### **Submission to Parliamentary Committee: New Parliamentary Inquiry on Disability Access Standards**

**Submission to Parliamentary Committee:  
New Parliamentary Inquiry on Disability Access Standards  
ISSUES RELATED TO HERITAGE BUILDINGS**

## STANDARDS AUSTRALIA COMMITTEE ME-064 ACCESS FOR PEOPLE WITH DISABILITIES DESIGN FOR ACCESS AND MOBILITY<sup>1</sup>

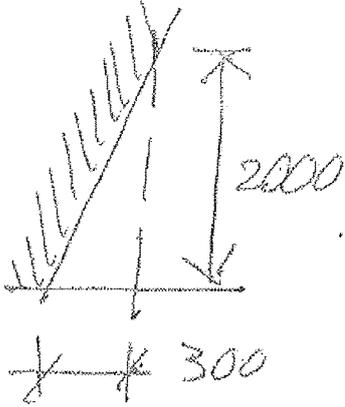
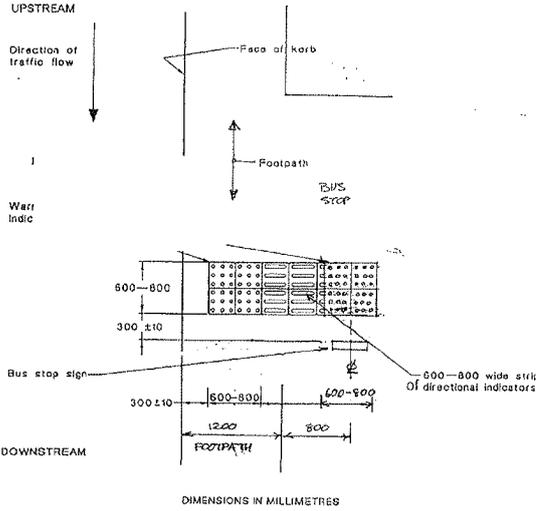
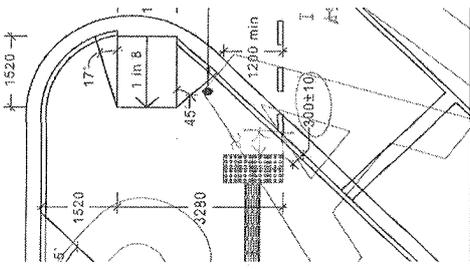
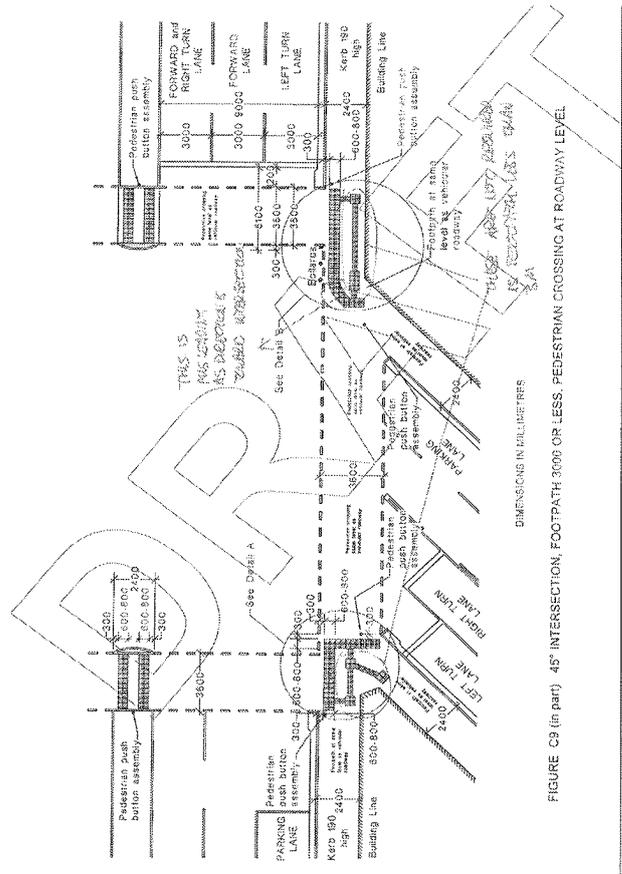
Figure 7	It would be useful to define what minimum height or gap is acceptable without TGSi eg normal accepted gap is 300mm. The situation of what is acceptable for a sloping wall or structure before TGSi are required should be defined. The following is suggested:

<p>When 2000mm is not achieved within 300mm a barrier or TGSi are required.</p>
	<p>Figure 11</p>	<p>Please provide a layout for a bus stop with a footpath against a kerb, eg</p>  <p style="text-align: right;">Figure 4.13-D Bus stops</p>
<p><b>Appendix C Kerb Ramps, Medians and Multiple Entry Points</b></p>	<p>Figure C1</p>	<p>The 1200mm access width (B) is supported. AS1428.1 identifies that the space should be this wide. This comment applies to other drawings in this draft.</p>
	<p>Figure C2(A)</p>	<p>Please illustrate non-standard curves or where kerb ramp is in a wide curve.</p>
	<p>Figure C2(C)</p>	<p>Please identify the minimum acceptable angle for sloping surface next to ramp (shown as 27°). We note that 45° angle shown at corner. What happens when 45° cannot be achieved? ie. is it acceptable as is indicated elsewhere including down to 17° in fig.C8</p>
	<p>Figure C2(F)</p>	<p>Extend directional indicators to meet tactiles in both directions to be consistent with principle that directional should extend between warning indicators</p>
